KEFORD COLLISION AND TOWING JZ 18-32 with Rezoning 18.725

Public hearing at the request of Keford Collision and Towing for Planning Commission's recommendation to the City Council for rezoning from I-1 (Light Industrial) to I-2 (General Industrial) with a Planned Rezoning Overlay (PRO). The subject property is approximately 7.61 acres and is located on the south side of Grand River Avenue between Taft Road and Novi Road (Section 15). The subject property contains two existing buildings which are currently unoccupied. The applicant proposes to use the larger building (23,493 square feet) for an auto body collision repair shop and related offices, along with an accessory use of car rental services.

PLAN REVIEW CENTER REPORT

KEFORD COLLISION & TOWING
PRELIMINARY GRADING PLAN
SECTION: 15
45241 GRAND RIVER AVENUE
PARCEL 6 E
TOWNSHIP 15 N
COUNTY OF OAKLAND
MICHIGAN

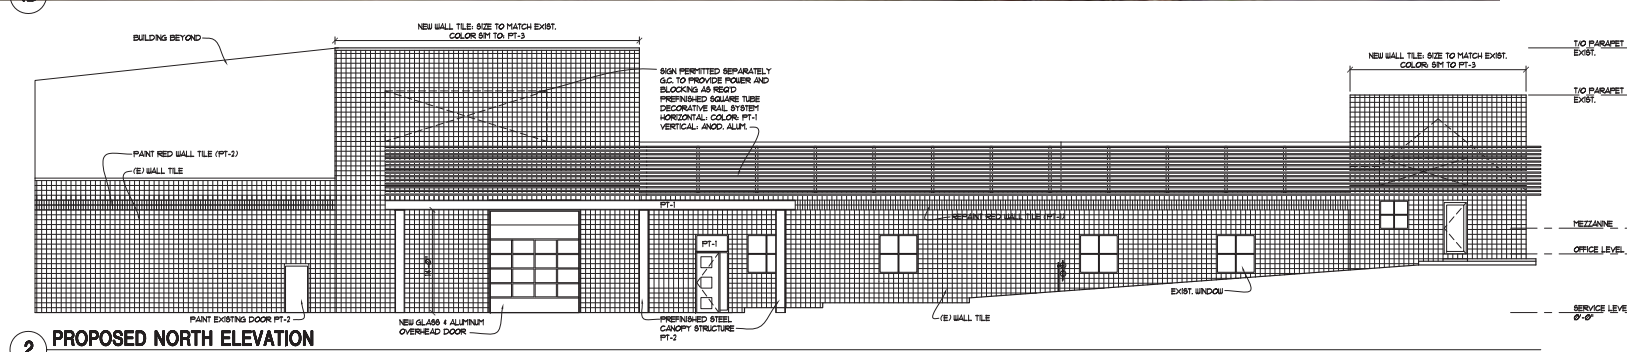
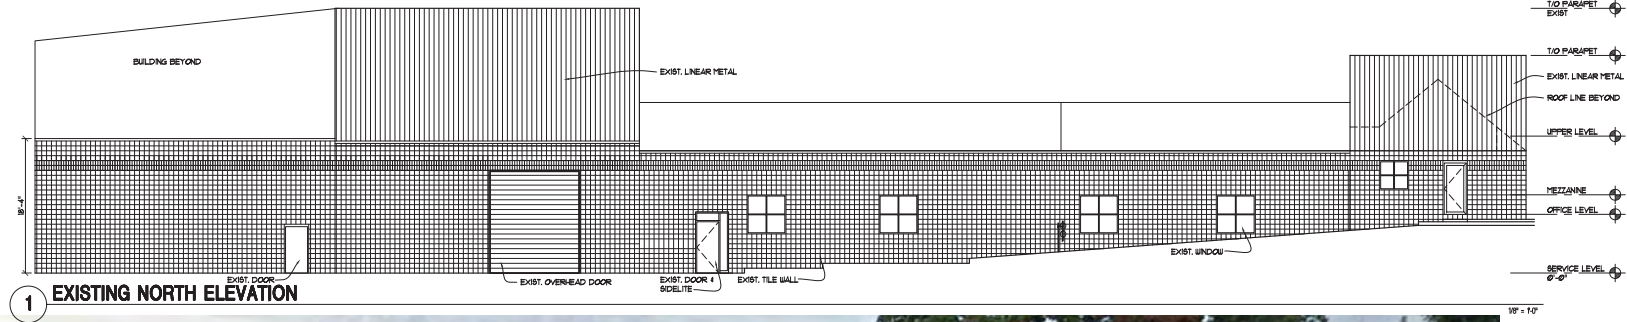
1. Provided on L-3.
2. **Please show tree fencing at the Critical Root Zone (1’ beyond dripline) for all existing trees to remain near the project area on the Grading Plan (Sheet 3).**

Figure 1. City of Novi Regulated Wetland & Woodland Map (approximate parcel boundary shown in red). Regulated Woodland areas are shown in green and Regulated Wetland areas are shown in blue.

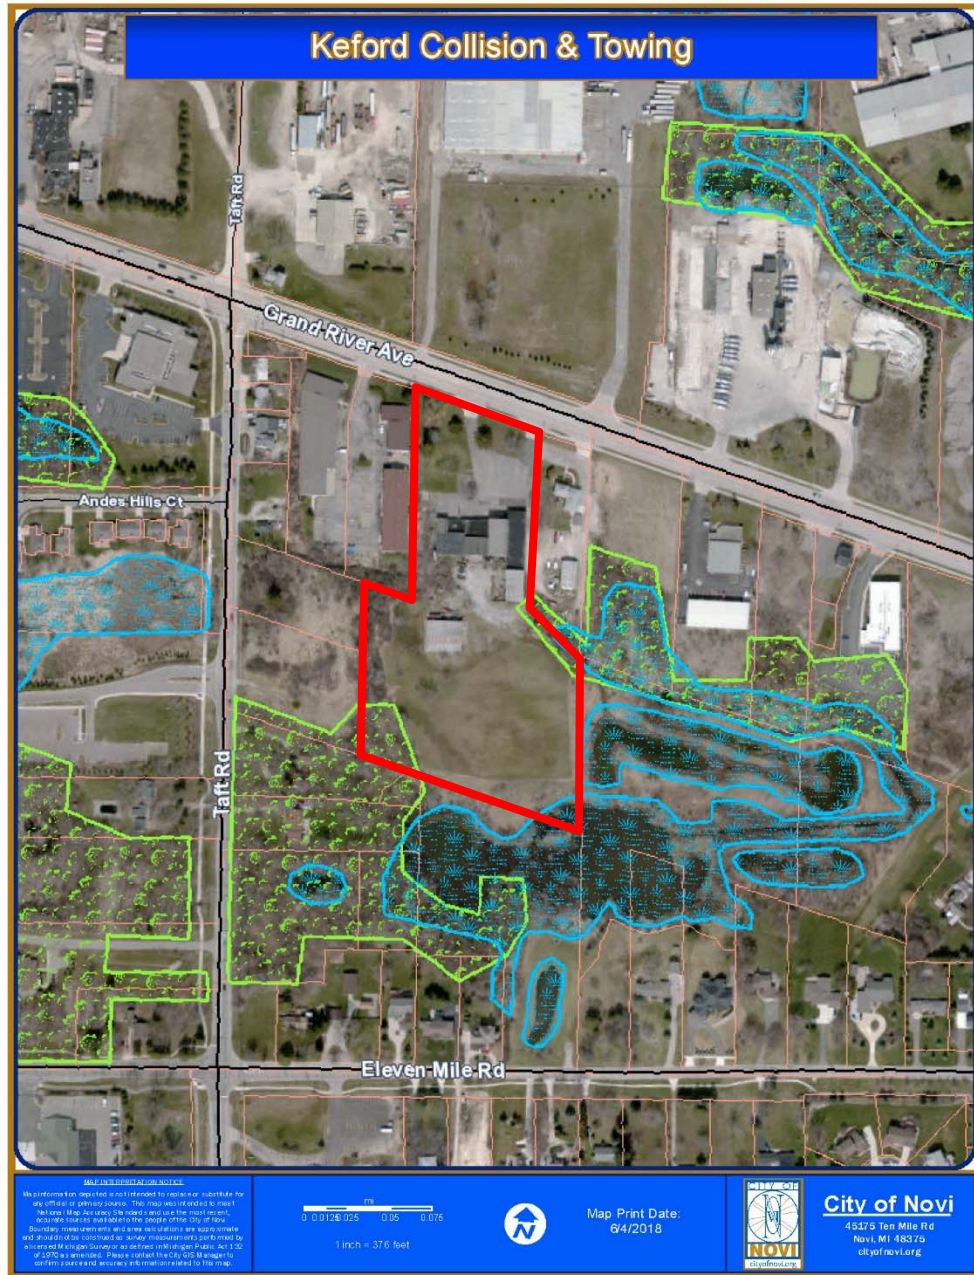
It should be noted that the wetland and wetland buffer boundaries indicated on the Plan appear to be approximate. Subsequent site plan submittals shall include the actual, surveyed wetland boundary information that appears to be included on the Wetland Delineation map provided by KME (Figure 2). The wetland flag numbers shall also be provided on the Plan.

As such it is unclear if the proposed site work will impact Wetland C, however it does not appear likely. The boundaries of Wetland C are not currently shown on Sheet 1. This information should be provided/clarified on subsequent site plan submittals.

Figure 1. City of Novi Regulated Wetland & Woodland Map (approximate parcel boundary shown in red). Regulated Woodland areas are shown in green and Regulated Wetland areas are shown in blue.

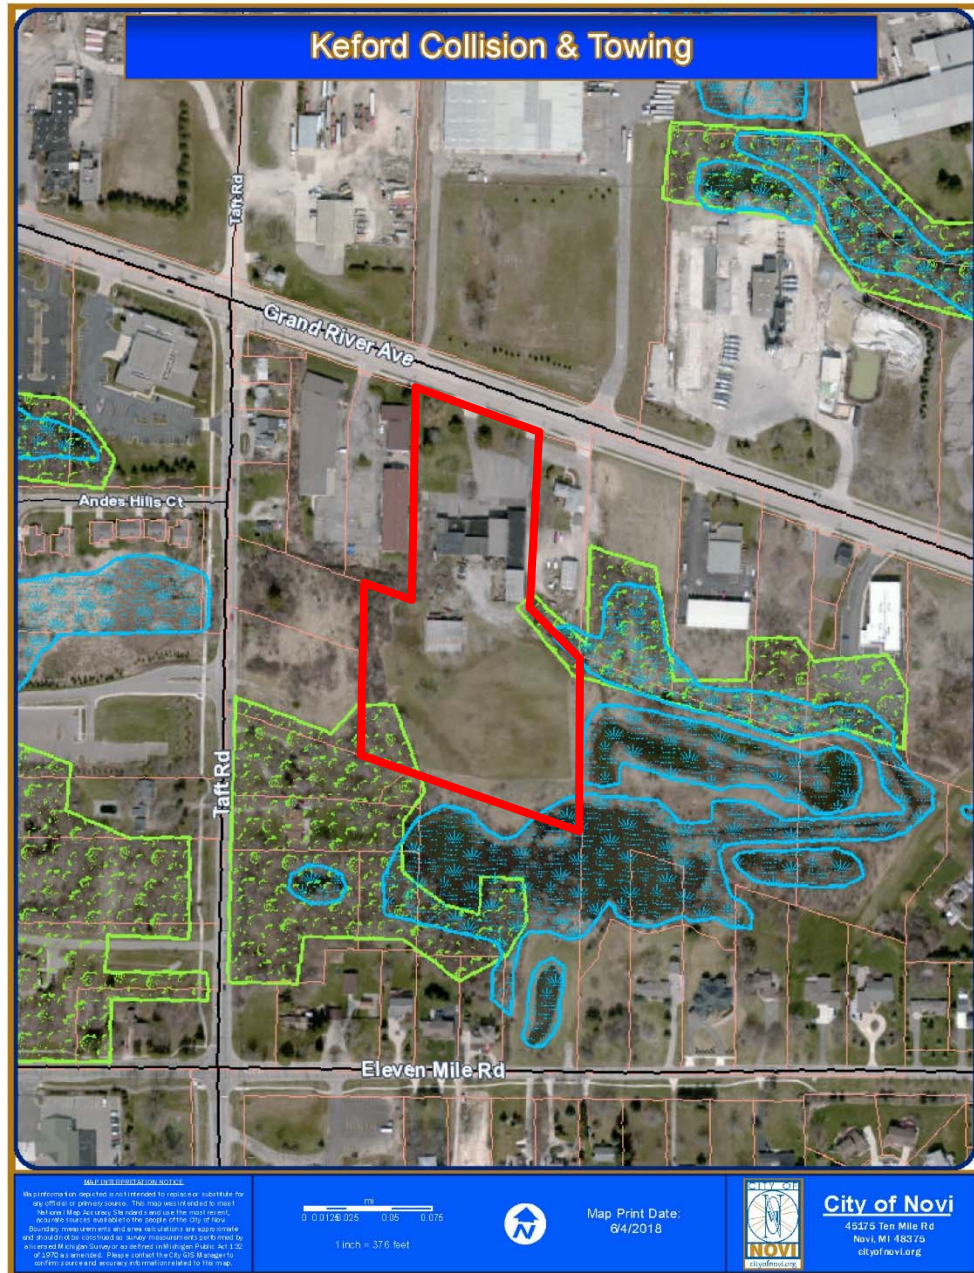
It should be noted that the wetland and wetland buffer boundaries indicated on the Plan appear to be approximate. Subsequent site plan submittals shall include the actual, surveyed wetland boundary information that appears to be included on the Wetland Delineation map provided by KME (Figure 2). The wetland flag numbers shall also be provided on the Plan.

As such it is unclear if the proposed site work will impact Wetland C, however it does not appear likely. The boundaries of Wetland C are not currently shown on Sheet 1. This information should be provided/clarified on subsequent site plan submittals.
